# ISSUE RESOLUTION STATUS REPORT

## KEY TECHNICAL ISSUE: CONTAINER LIFE AND SOURCE TERM

Division of Waste Management  
Office of Nuclear Material Safety and Safeguards  
U.S. Nuclear Regulatory Commission

Revision 2

**Figure 6. Effect of chloride concentration on repassivation potential of three different CRAs**

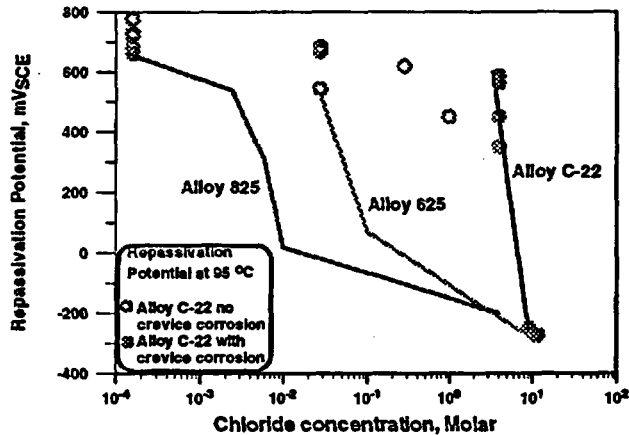
- (3) The critical temperature for localized corrosion is assumed in the TSPA-VA to be independent of chloride concentration or corrosion potential. As shown in Figure 6, the critical temperature is dependent on both chloride concentration and potential.
